Park Lane, Histon Cycleway crossing.

To: South Cambridgeshire District Council

From Bob Menzies, Head of Delivery, Cambridgeshire Guided Busway

Picture 1 North west corner of junction showing all vegetation removed.

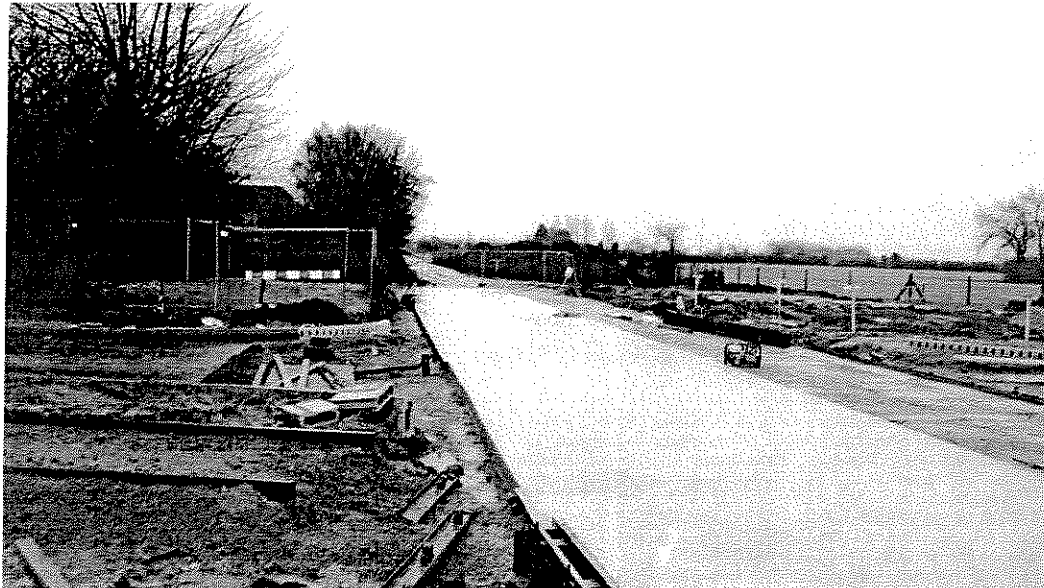
The safety audit suggested a controlled crossing to address a potential visibility problem. The safety audit was undertaken before vegetation was cleared from the junction. There is no longer any vegetation on this corner as shown in picture 1. Nonetheless to ensure that the visibility does not require looking over land not in control of the County Council the layout has been altered to bring the kerbline forward.
